Move Rolla TDD University Drive Relocation US 63 Traffic Analysis Addendum

April 27, 2020

A – FHWA Feedback

UNIVERSITY DRIVE REALIGNMENT
160' ROUNDABOUT

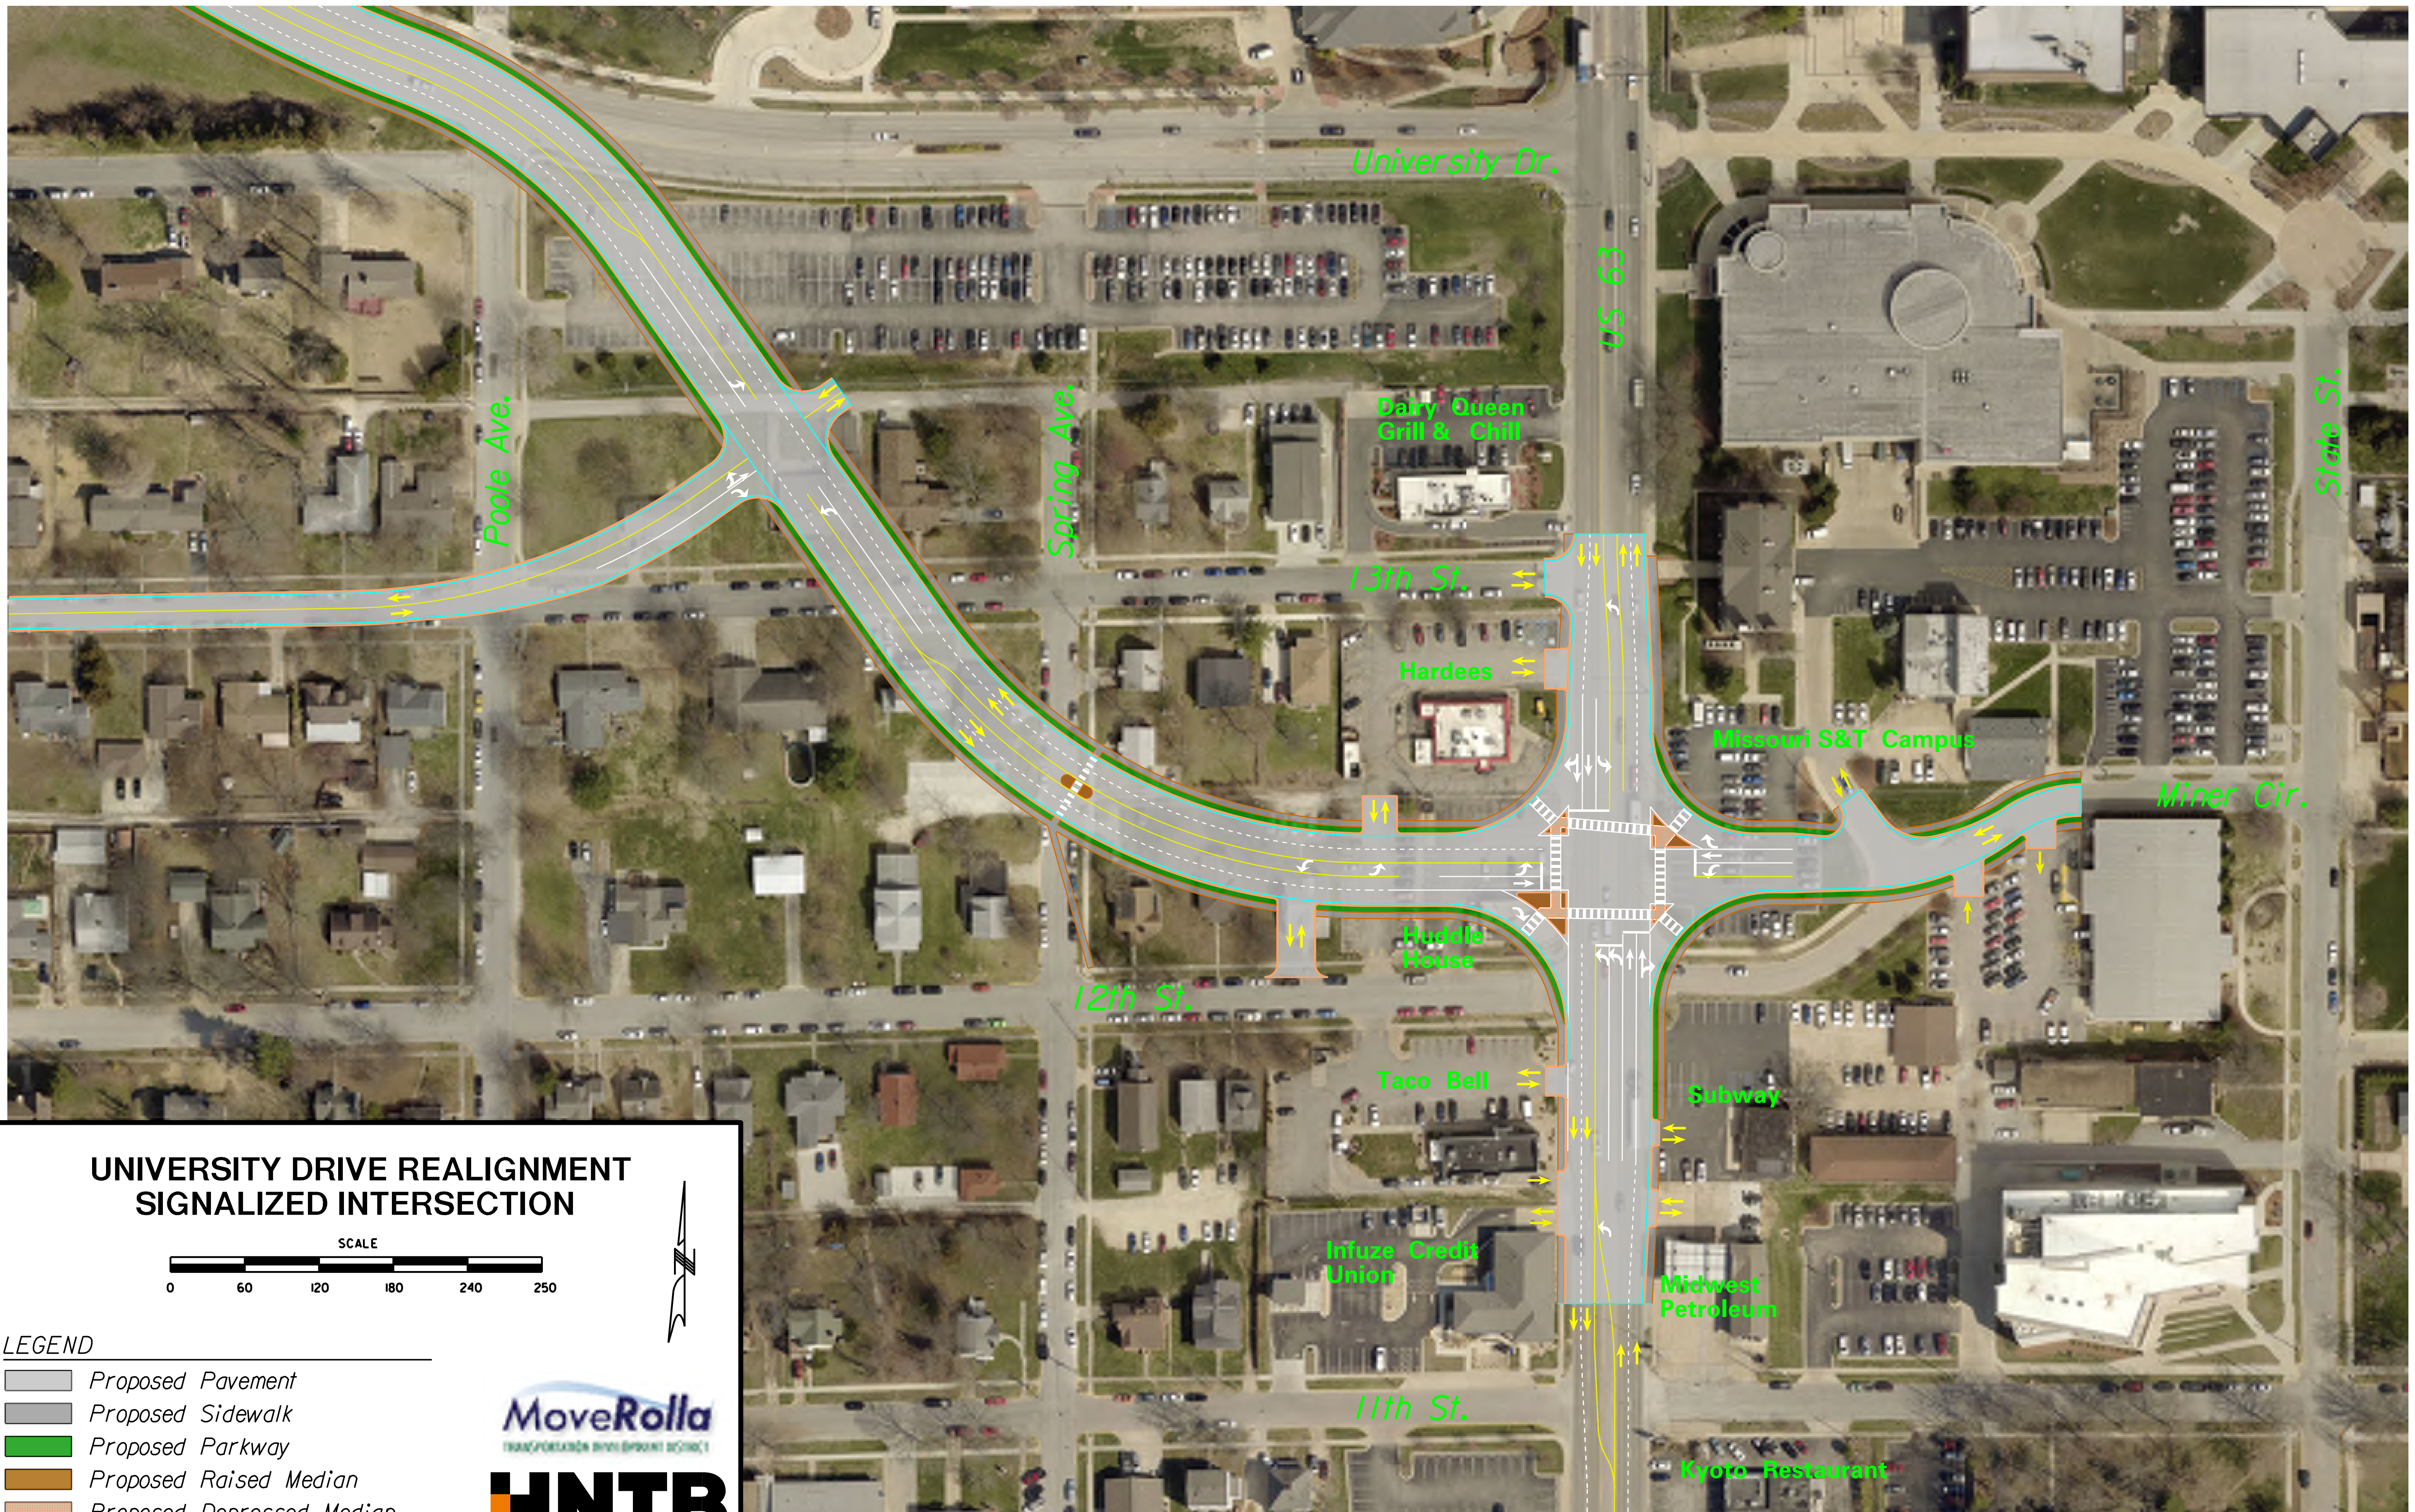
- 150' - 160' diameter is typical size for a hybrid roundabout. 160' is best place to start.
- FHWA encourages right sizing to reduce speeds, use less ROW, and create better connections.

- FHWA thinks the Rolla 2-lane roundabout is borderline in 2040 when taking a broad look at the data.
- FHWA has seen communities that think if you don't need 2-lanes for 10 years then don't build 2-lanes at first.

- Fewer lanes = less risk for cars and pedestrians.
- FHWA design for pedestrian crossing guidance for the approach is one car / 25ft. and departure is 30' to 70'

- Offset pedestrian two-stage crossing is acceptable.
- 160' diameter roundabout is within the guidance for roundabout diameters for trucks. Based on Rolla truck volumes the City should not expect significant truck impact

- Designing a single southbound lane initially with the intention to convert to double lane in the future is acceptable
- Volume is very borderline in looking at a single vs double lane, even in 2040. Always go with a single lane first if at all possible, multiple factors must be considered for double lane.

- Research has shown vehicles yield more on the entrance as opposed to the exit of the roundabout. This has led to the placement of the offset at the exit further from the circulatory road than the entrance.
